Re: Interpretation for PCA/FDPA 89-C-060-02; Dulles Greene

RE: Interpretation for PCA/FDPA 89-D-060-2
Dulles Greens Land Bays 2 & 3
Project #961907.00

This is a request for an interpretation of the +/- 65' dimension shown on the Proffer Interpretation Plan dated February 5, 1999 and last revised on October 1, 1999, prepared by christopher consultants, ltd. This dimension is from the northern property line to Building "EE" on the above referenced plan. The final site plan titled "Dulles Greens Land Bays 2 & 3", Fairfax County Plan #9479-SP-04, was approved with a +/- 54' setback at this location. Subsequently, Building "EE" was built per the approved site plan and honored the setback shown on the approved site plan. We believe this interpretation is justified based upon Proffer 2a and Section 16-403, paragraph 4 which states that minor modifications to an approved Final Development Plan may be permitted when it is determined by the Zoning Administrator that such are in substantial conformance with the approved Final Development Plan.

SHEET
2 of 4
C - 3490

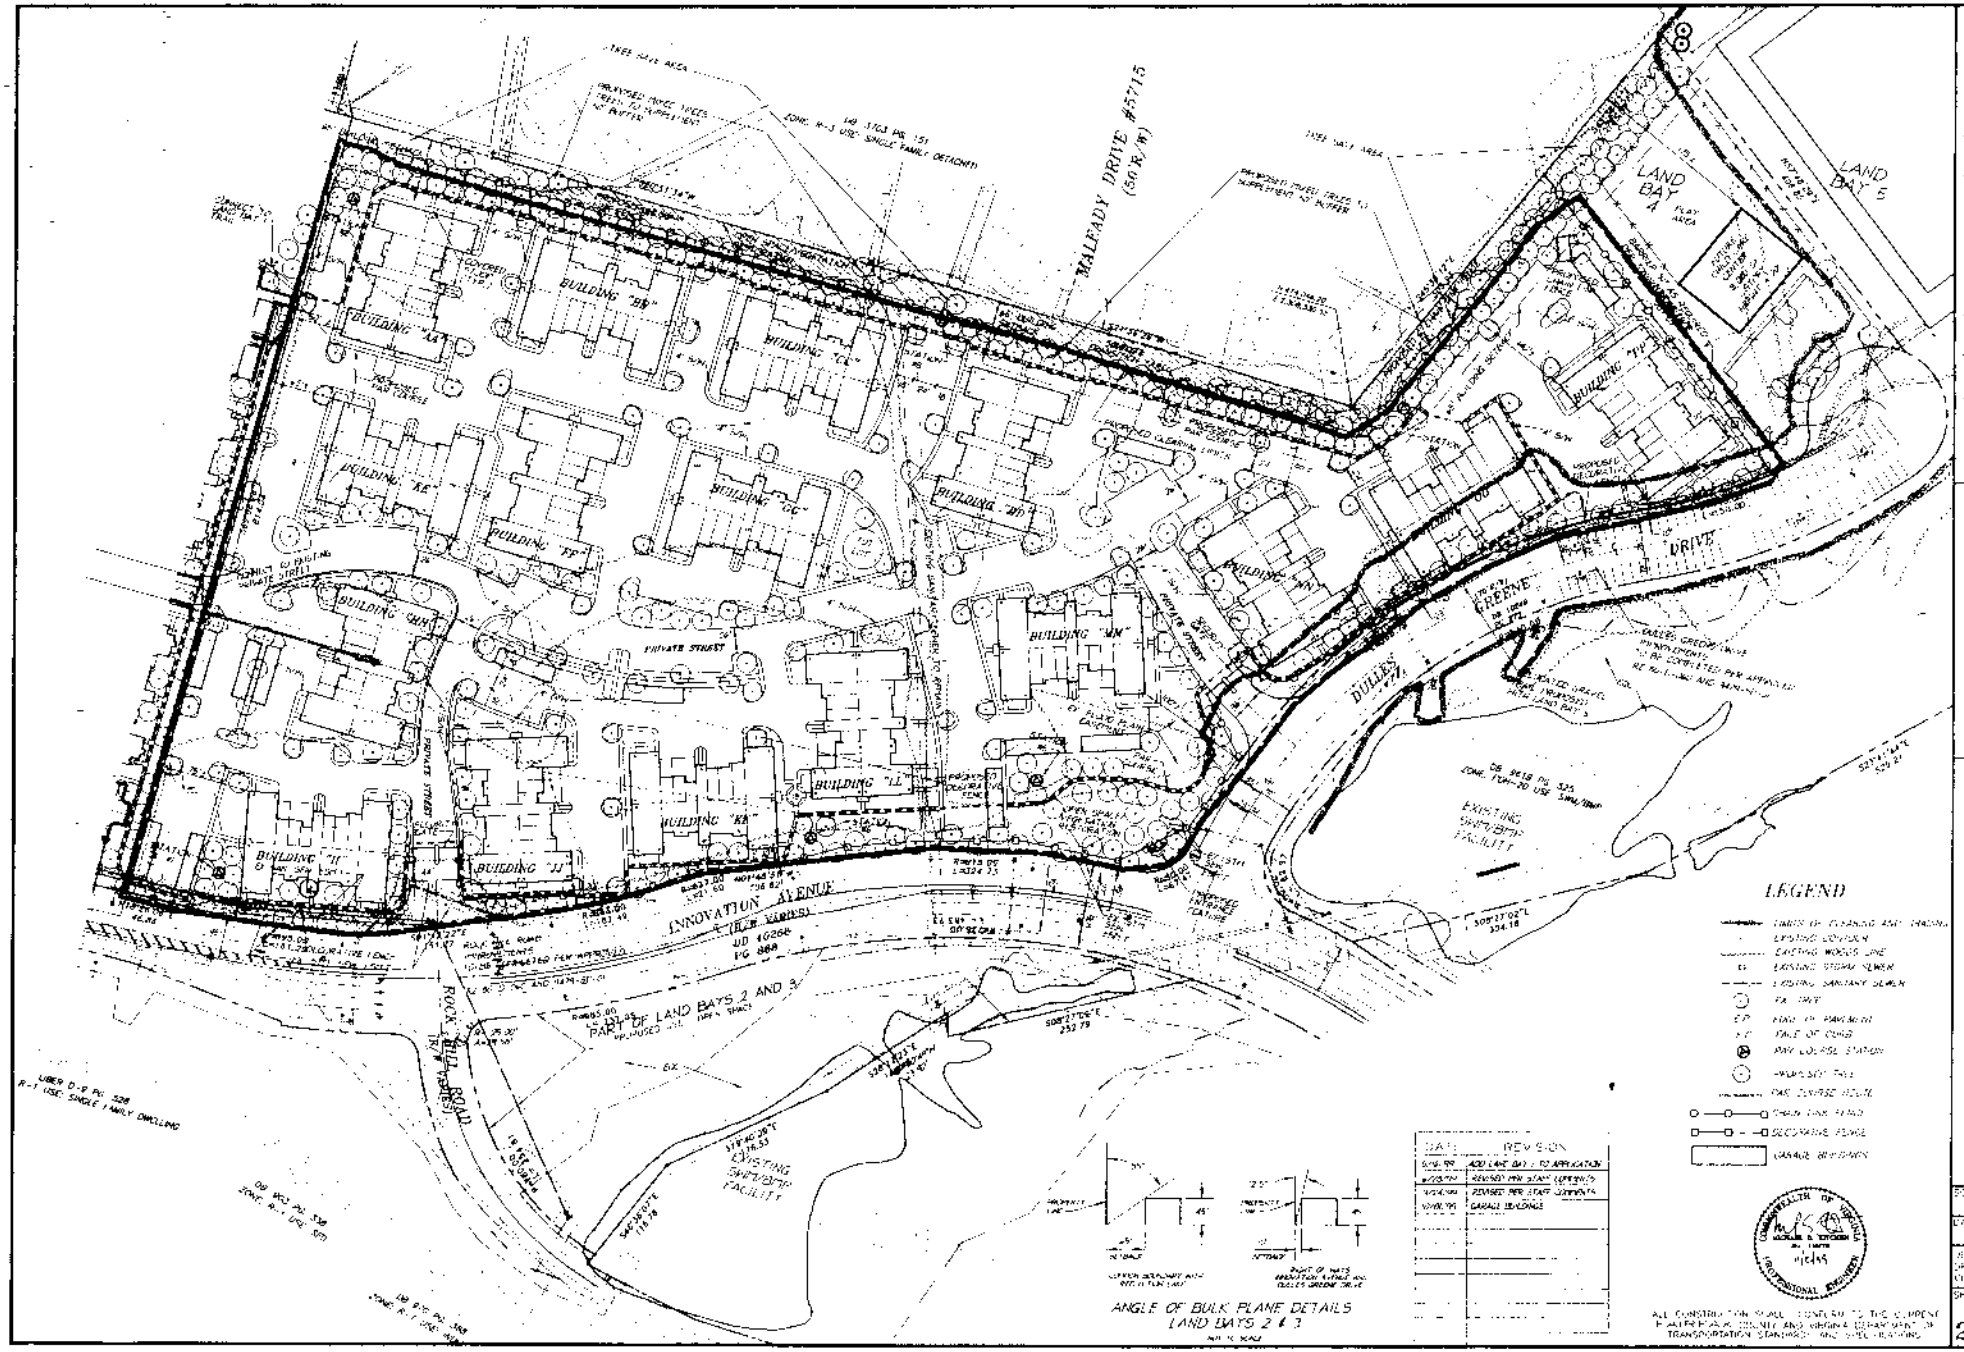
The approved CDPA/FDPA for PCA 89-D-060-02 depicted a dimension of sixty-five feet between Building EE and the boundary of Land Bays 2 & 3. The CDPA/FDPA further depicted approximately a seventy-five foot separation between Building EE and Building K in Land Bay 1. Building EE is internal to the Dulles Greene development. The site plan for the project was approved with a fifty-four foot setback between Building EE and the boundary of Land Bays 2 & 3 and approximately seventy-five feet in separation between Building EE and Building K. It is my understanding that the Building EE location was modified to accommodate utilities and to match the setback of adjacent Building AA in order to provide a uniform street and streetscape.

- The +/- 65' setback shown on the CDPA/FDPA is "internal" to the site and not located at the periphery boundary of the site. This zone does not have a setback requirement as it is PDH-20. In the PDH-20 zone, peripheral lot setbacks are required and we have met all of those.

- There is approximately 75' between Building "EE" and the adjacent building located in Dulles Greens Land Bay 1. The approved CDPA/FDPA had shown approximately 10' from the property line to the Building in Land Bay 1. That would have provided a total setback of 65' as shown on Land Bay 2 and 10 from Land Bay 1 for a total of 75'. Therefore, the intent of "special" separation between buildings has been maintained.

- The adjoining building, (Building "AA") along San Moritz Circle has a 50' setback from the same internal property line. By reducing the setback for Building EE to match that of Building "AA", a uniform street section and treescape is created.

It is my determination that the proposed Building EE location is in substantial conformance with the proffers and Conceptual/Final Development Plan Amendment. This determination has been made in my capacity as the duly authorized agent of the Zoning Administrator. If you have any questions regarding this interpretation, please feel free to contact William Mayland at (703) 324-1290.

SITE PLAN

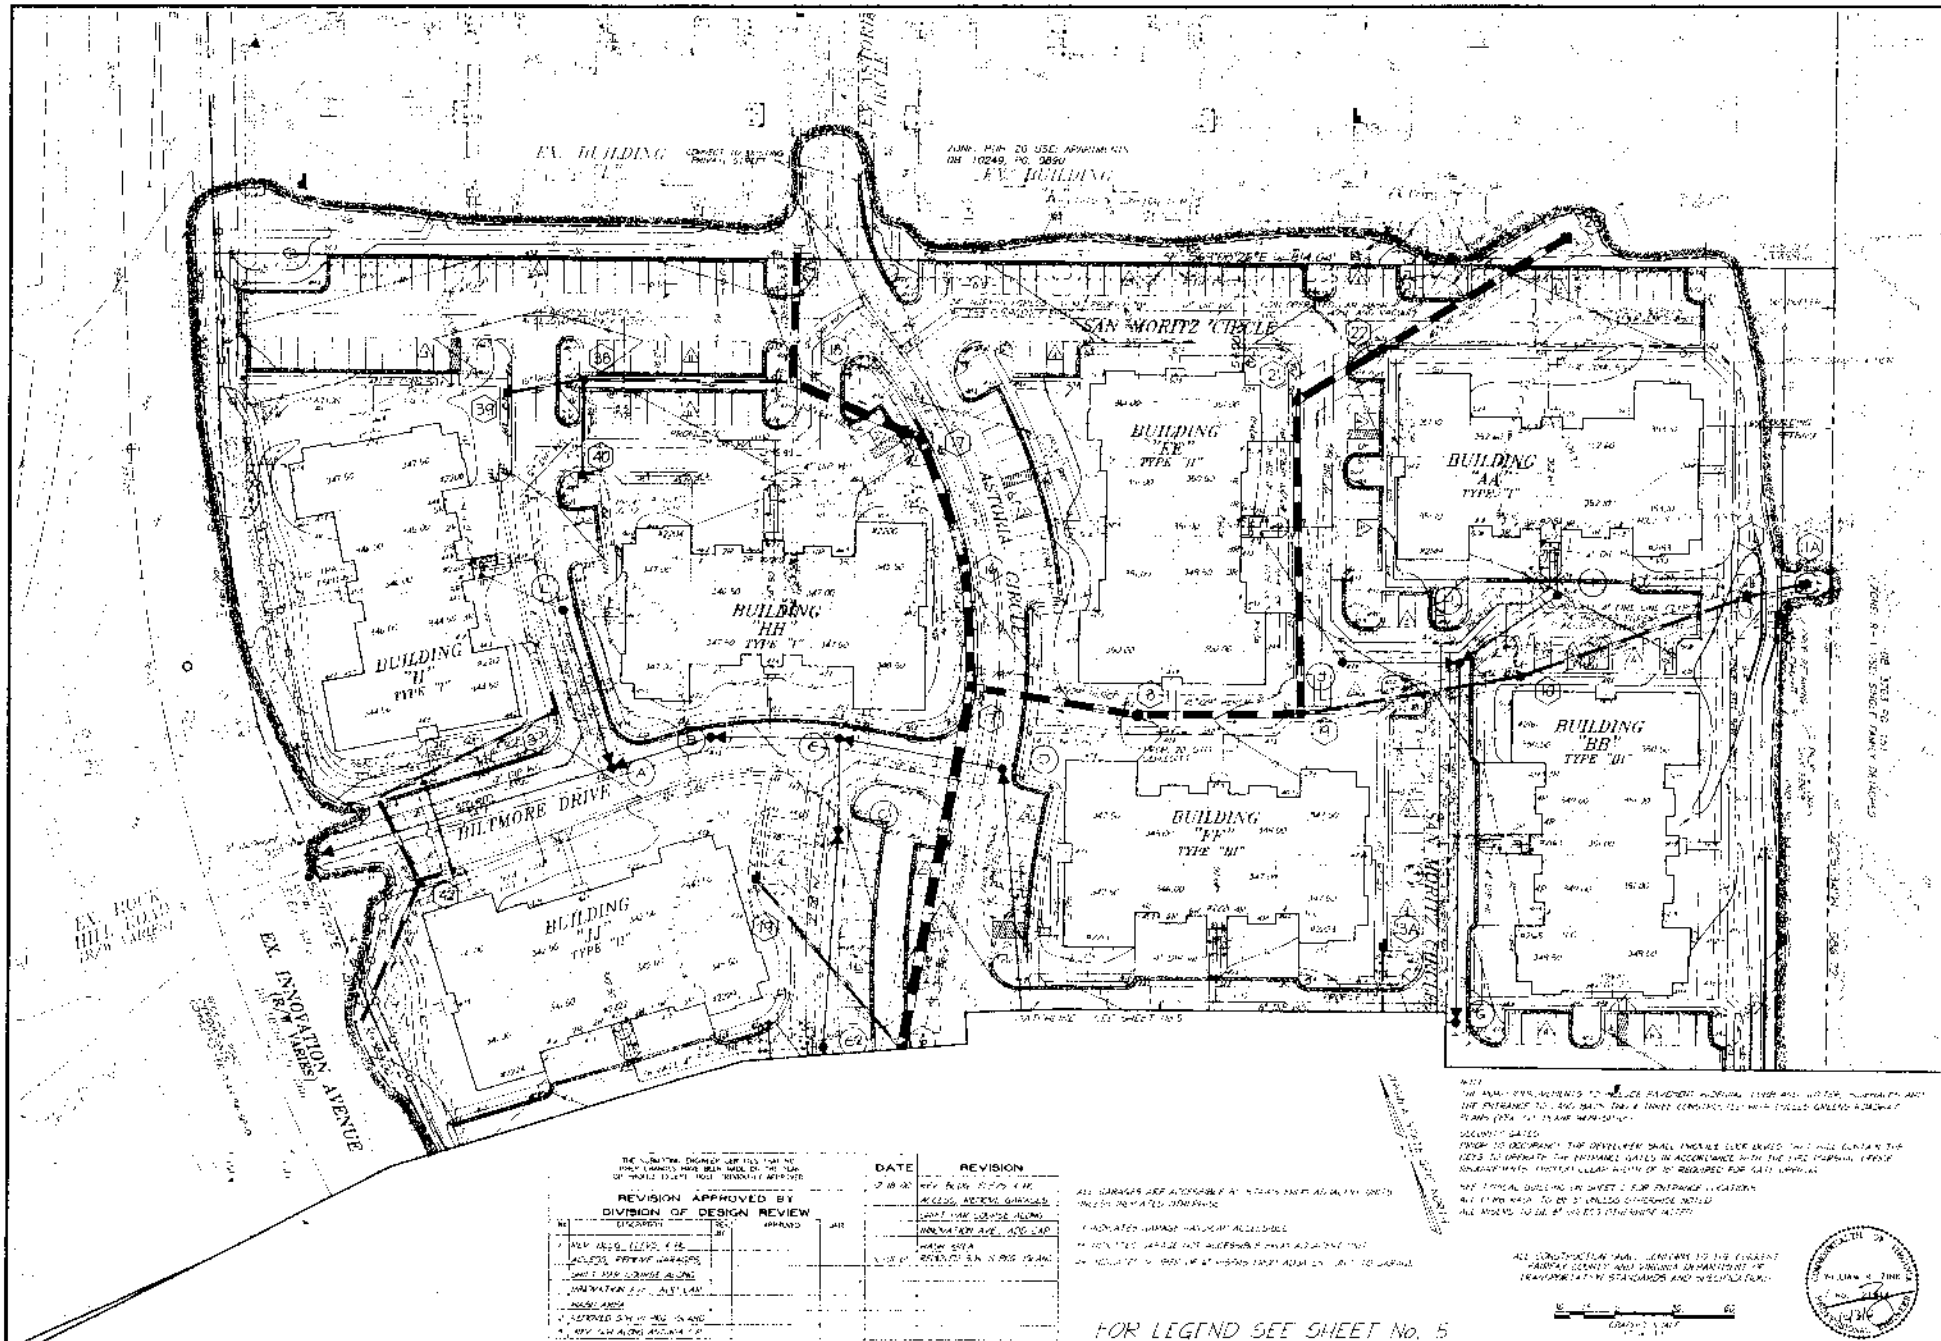
- Final engineering of the utilities required shifting of Building "EE" to the north to accommodate the required utility easement width and maintain the loading plane distance with the storm sewer pipe located on the southern side of the building. Thus, final engineering of the site is the principal cause of this shift.
